## OIL CONSERVATION DIVISION

Dee 36 SE State

## SUNDRY NOTICES AND REPORTS ON WELLS

Yates Petroleum Corporation plans to plug and abandon this well as follows:

WELL NAME: Dee 36SE State #5 FIELD: N. Dagger Draw U. Penn  
 LOCATION: 990' FSL & 990' FEL of Section 36-19S-24E Eddy, NM  
 GL: 3,592' ZERO:  KB: 3,610'  
 SPUD DATE: 6/8/81 COMPLETION DATE: 7/13/91  
 COMMENTS: API No.: 30-015-26671

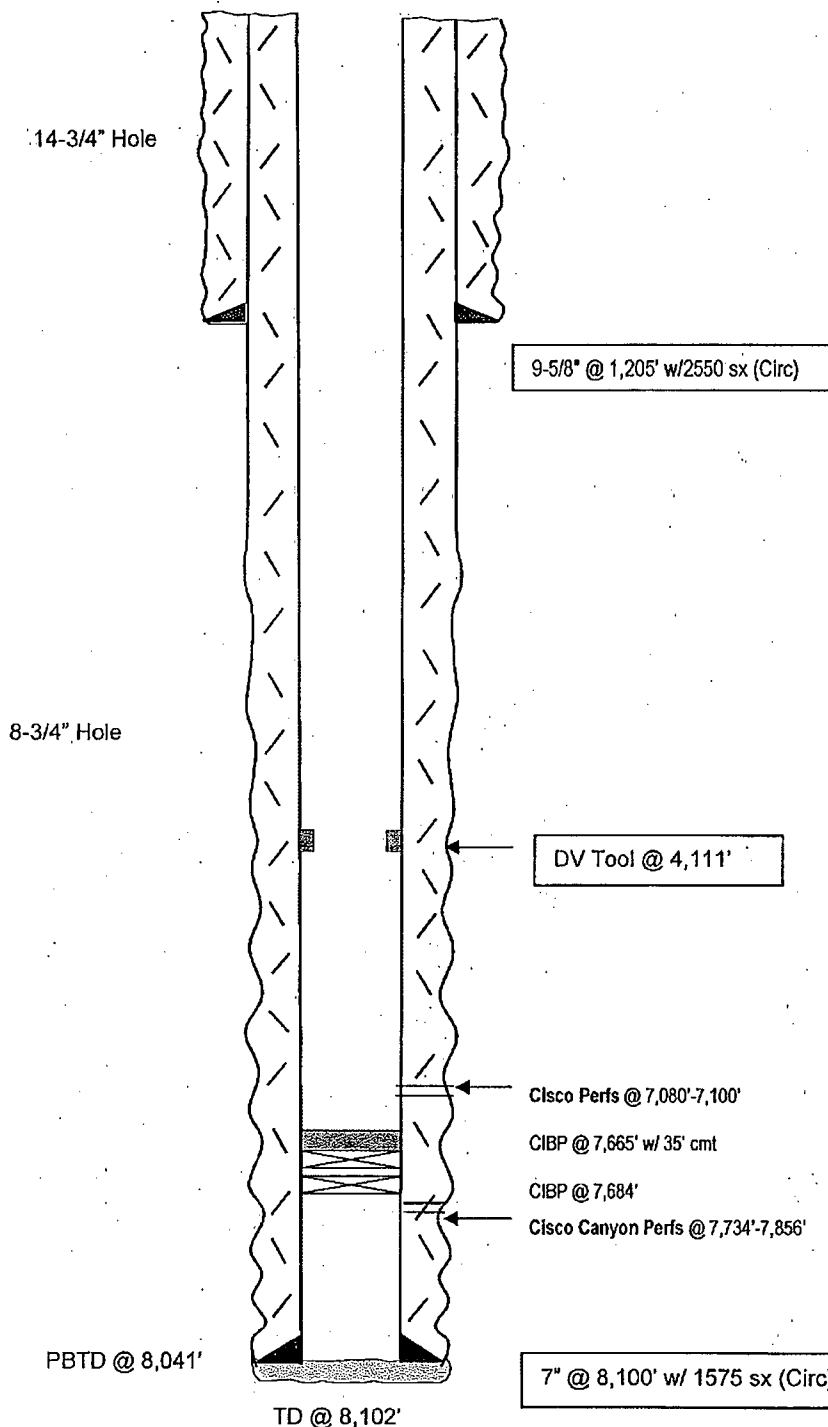
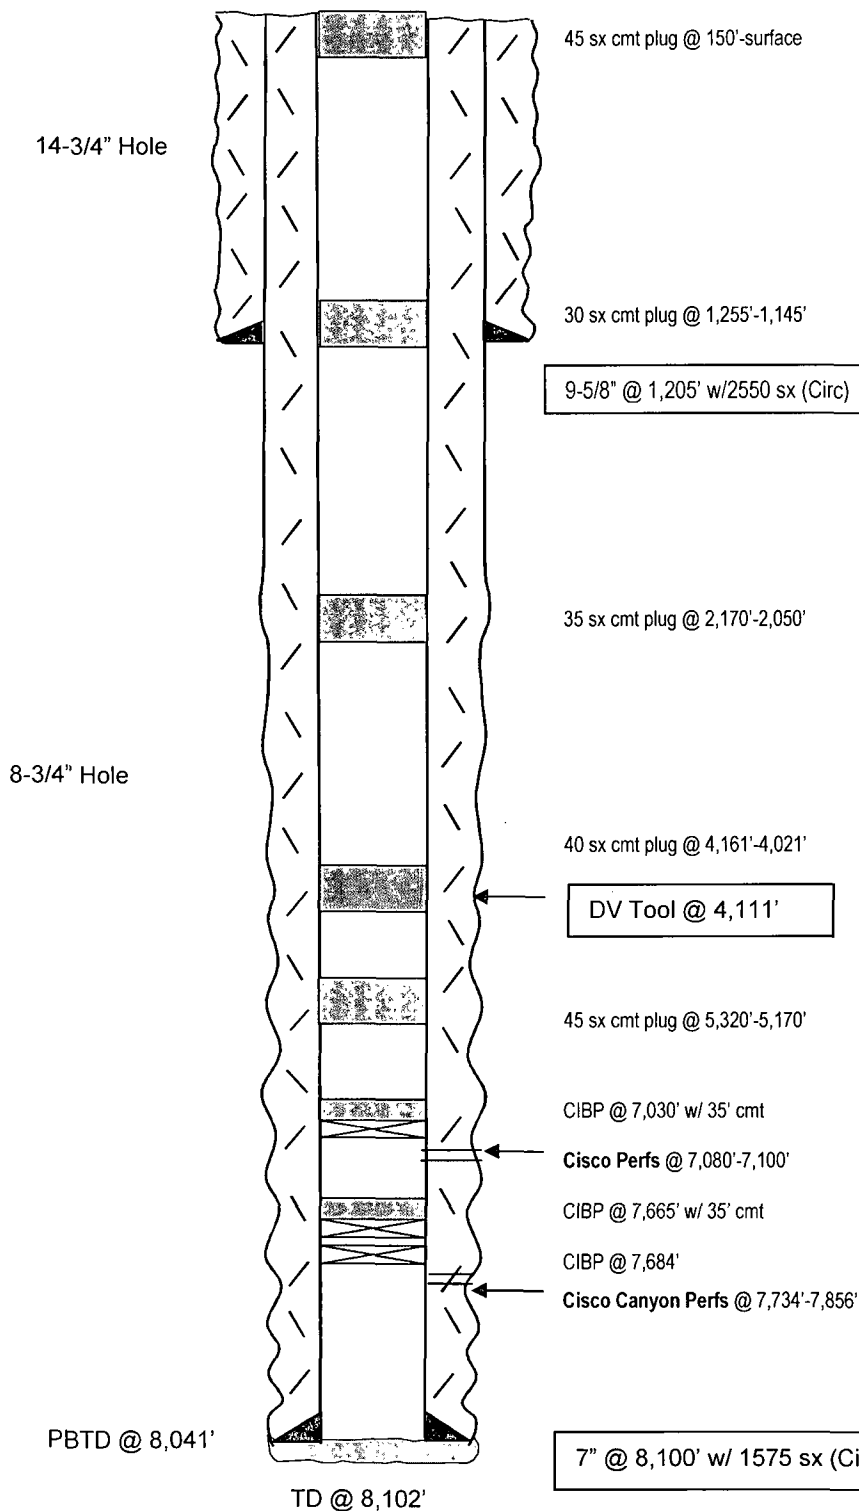
1. MIRU all safety equipment as needed. NU BOP. RIH with GR/JB to 7040'. Set a 7" CIBP at 7030' then dump 35' Class "H" cement on top.
2. Spot a 45 sx Class "C" cement plug from 5320'-5170'. This will cover top of Wolfcamp.
3. Spot a 40 sx Class "C" cement plug from 4161'-4021'. This will cover DV tool.
4. Spot a 35 sx Class "C" cement plug from 2170'-2050'. This will cover top of Glorieta.
5. Spot a 30 sx Class "C" cement plug from 1255'-1145'. This will cover 9-5/8" casing shoe. WOC and tag.
6. Spot a 45 sx Class "C" cement plug from 150' up to surface.
7. Cut off wellhead, install dry hole marker and clean location.

Approved for plugging of well bore only.  
 Liability under bond is retained pending receipt  
 of C-103 (Subsequent Report of Well-Plugging)  
 which may be found on OCD Web Page under  
 Forms, www.cmnrd.state.nm.us/oed.

well must be plugged by 5/8/2016

1. Produced water **will not** be used during any part of the plugging & abandonment operation.
2. Notify NMOCD Dist. 2 office at least 24 hrs before beginning work.

7. Every attempt must be made to clean the well bore out to below the perms, before any plugs can be set, by whatever means possible.
8. **Cement Retainers may not be used.**

9. Squeeze pressures are not to exceed 500 PSI, unless approval is given by NMOCD.
10. Plugs may be combined after consulting with and getting approval from NMOCD.

11. Minimum WOC time for tag plugs will be 4 Hrs.
